Oregon State University
Construction Contract Administration
Hawley Hall Roof Replacement

ADDENDUM NO. 2

PARAPET @ PIPE CHASE

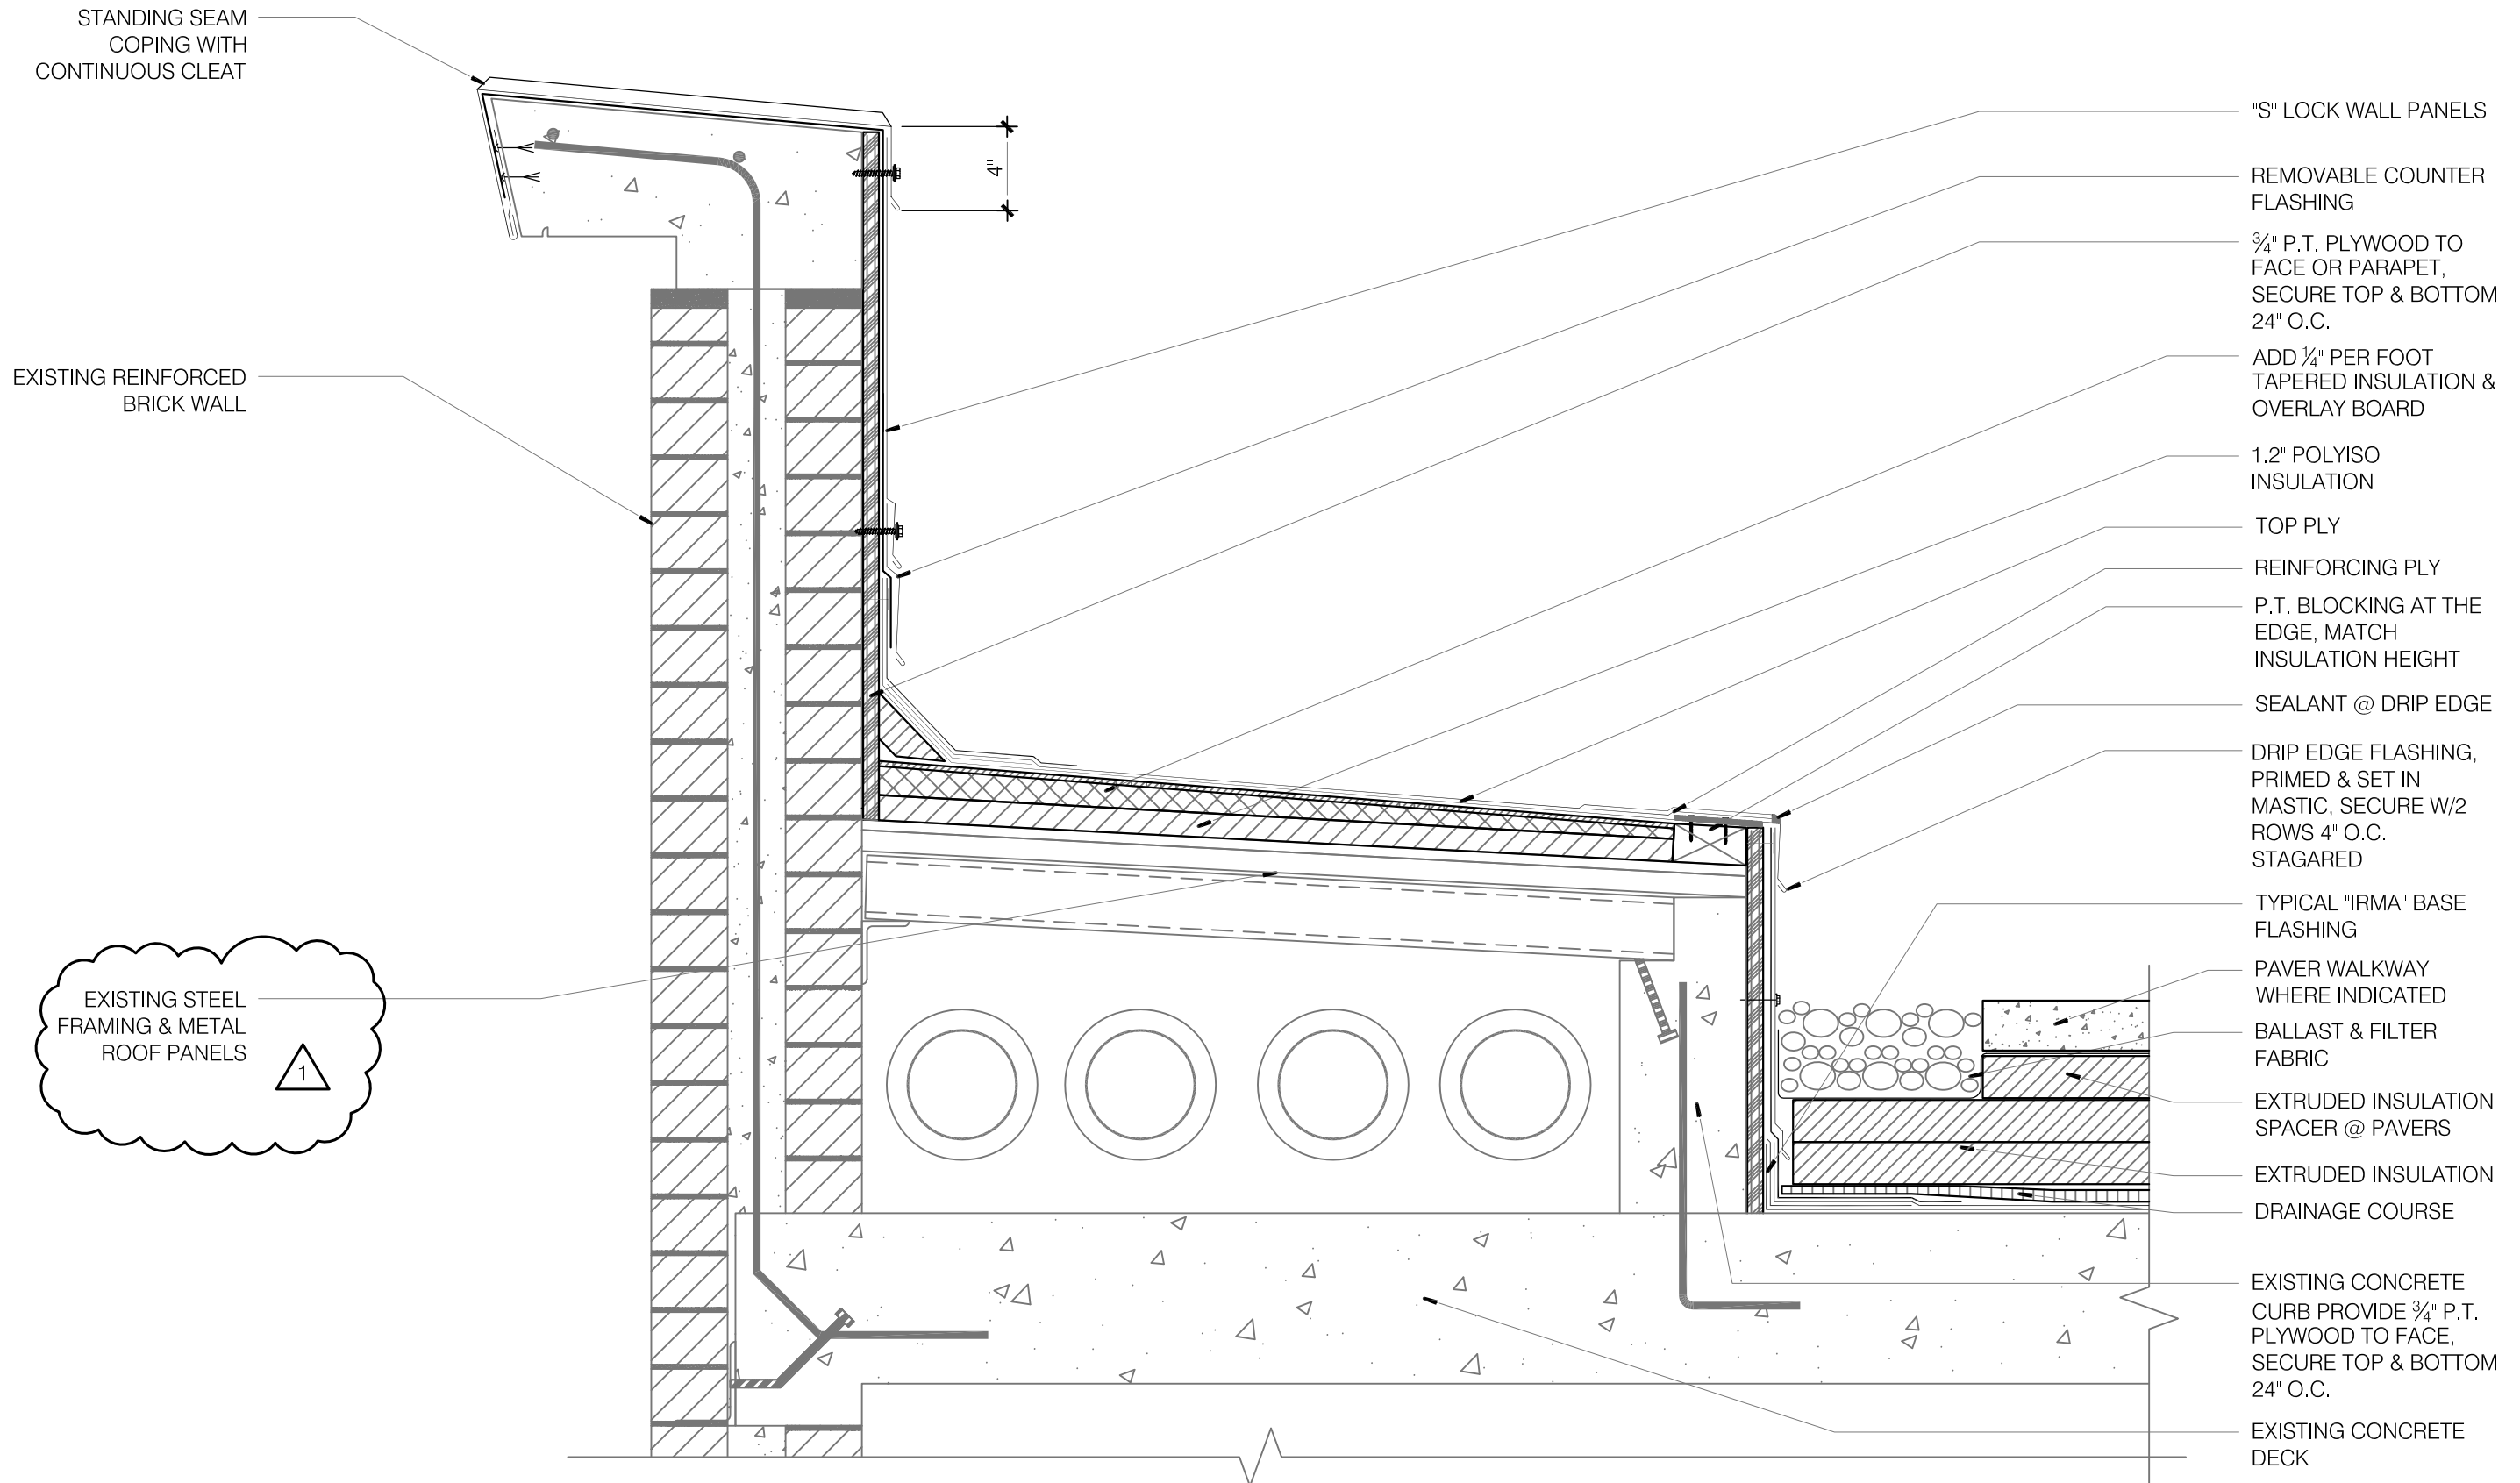
Item 1 UPDATE details sheet A8.1 section 5, A8.1 Parapet@ Pipe Chase. See Attached Drawing.
